STAFF RECOMMENDATION 1512 A Dallas Avenue September 19, 2018

Application: New Construction - Addition
District: Belmont-Hillsboro Neighborhood Conservation Zoning Overlay
Council District: 18
Map and Parcel Number: 11704012300
Applicant: Tyler LeMarinel
Project Lead: Sean Alexander, sean.alexander@nashville.gov

Roof Plan

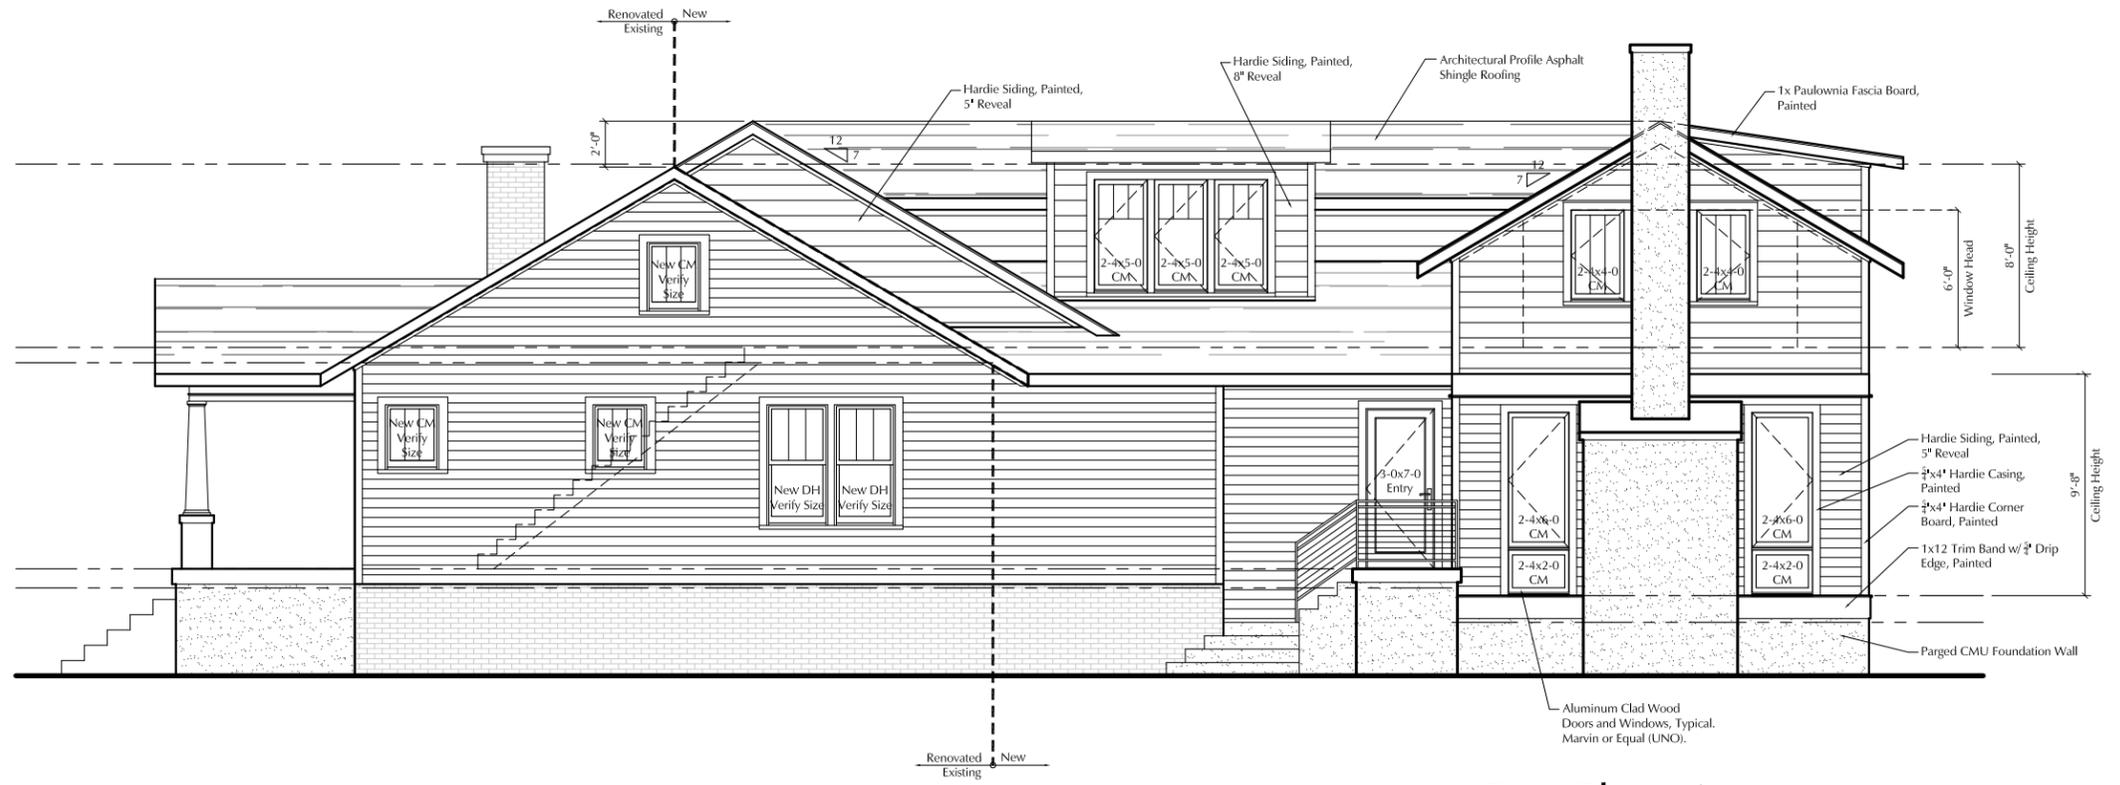
While it may be appropriate for a one story addition, if separated by an alcove or hyphen, to match the width of an historic house or to even be wider in limited situations, staff finds that the scale of the proposed addition is not appropriate because the roof and eave height are taller, making the form of the addition appear larger and to have a greater number of stories than the historic house. While this is the case for both sides of the

addition, it is particularly so on the left side where the new addition is actually taller and wider than the original structure.

While the ridge raise and first story insets of the addition are appropriate, Staff finds the scale of the upperstory is not subordinate to the original house. Staff recommends that the width of the upperstory is reduced in order to sit two feet (2') inside the silhouette of the historic house and meet sections II.B.1a and II.B.1.b of the design guidelines

Roof form: The primary roof of the addition will be a cross-gable, matching the 7:12 pitch of the original roof side gabled roof, with low-pitched shed dormers on both sides of the additions' middle section. These roof forms and pitches are common on historic houses throughout the area. Staff finds that the roof forms of the addition are compatible with the historic house and the project would meet Section II.B.1.e of the design guidelines if the addition was not taller and wider than the historic house one story house, giving it the appearance of having a second story.

1. The width of the upperstory shall be reduced to sit two feet (2') inside the silhouette of the historic house; and
2. Staff shall approve the roof color; and
3. Staff shall approve the window and door selections.

Drawings: Elevations	Date: 08.30.18
-------------------------	-------------------

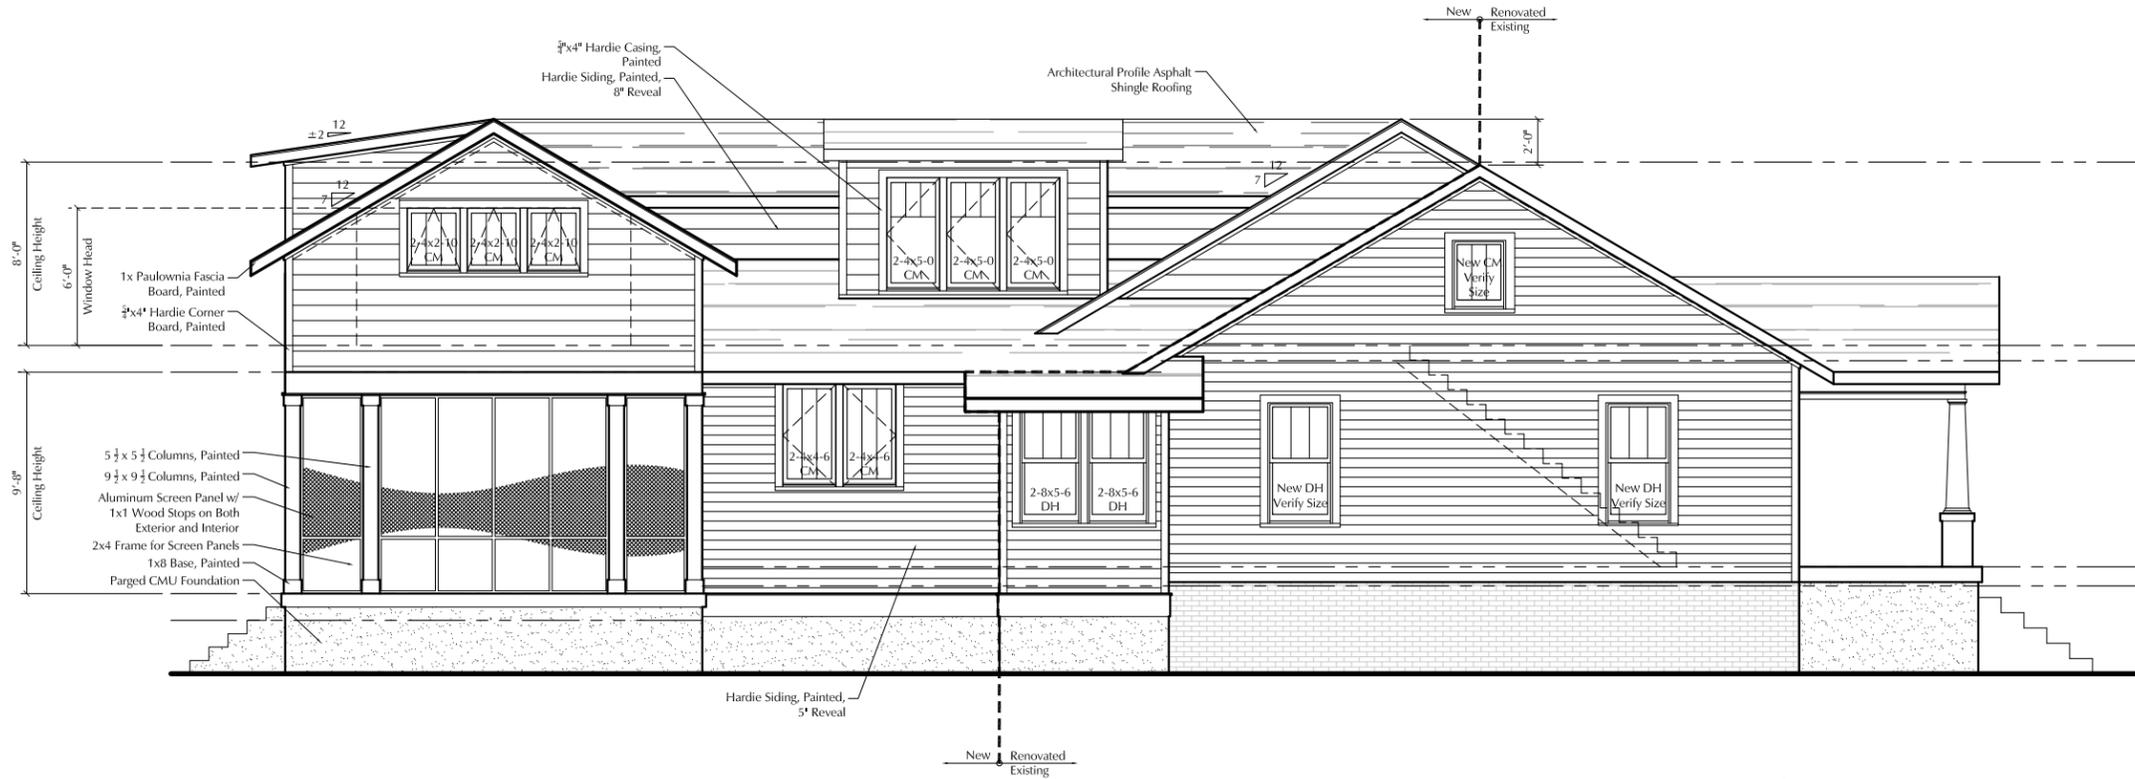
Height & Scale: The right side the addition will be stepped in two feet (2') from the side of the house and extend back ten feet (10') to the rear before stepping back out to be flush with the right side of the original house and continuing another eighteen feet (18') back. The twenty-eight foot (28") depth of the addition is sixty percent (60%) of the depth of the historic house. The left side will originate at the footprint of the existing addition and then step in two feet (2') and extend back thirteen feet (13') before stepping back out and also continuing eighteen feet (18') to the rear. Because the new addition matches and aligns with the side of a non-original portion of the building on the left side that is two feet (2') wider than the original house, the bulk of the addition's massing on that side is two feet (2') wider than the footprint of the original building.
